REMARKS

Application No.: 10/763,333
Art Unit 2879

Attorney Docket No. 0630-1942P
Reply to September 7, 2005 Office Action
Page 23

FIG. 6

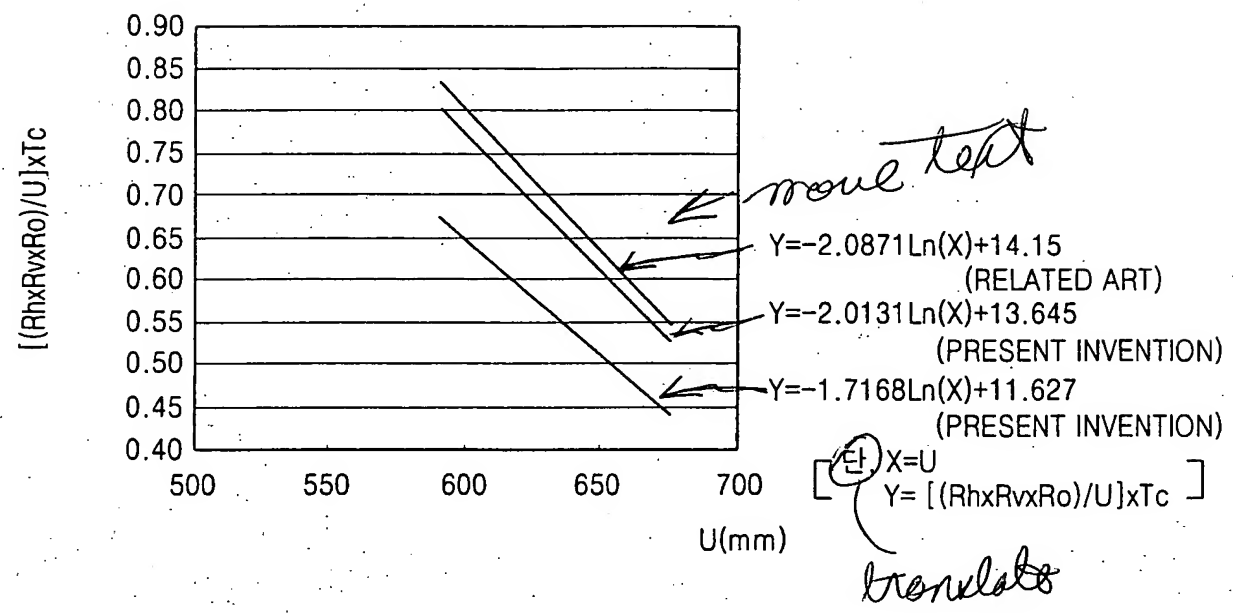
The Examiner has objected to the drawings because the plotted line that corresponds to each of the shown equations is not distinguishable because the style of the lines is identical.

The attached four (4) sheets of drawings include changes to Figs. 6-12. These four (4) sheets, which include Figs. 6-12, replace the original four (4) sheets that include those same Figures.

The legends currently located outside of the graphs have been moved inside of the graphs adjacent to the plots, which illustrate the legends. In this way, one legend is clearly associated with one plot. Also, the Kenji character found in the legend of each of Figs. 6-12 has been translated.
